Access Compliance Report Public Rights-of-Way (Curb Ramps)

Main Street: WEATHERBY_RD Cross Street: HARRISBURG_RD Location: SW

ADA ID: RPRK211215115458 Ramp Type: Type 1 - Perpendicular Diagonal Initial Pass/Fail: Fail Overall Compliance: No Severity Score: 15

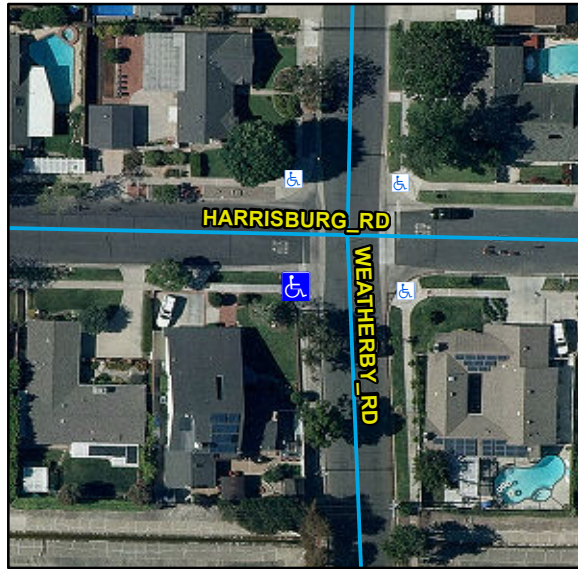
R304.2.2, R204.3, R302.7.2, STD 1115

Remove & Replace Curb Ramp With Two New Directional Ramps or Equivalent.
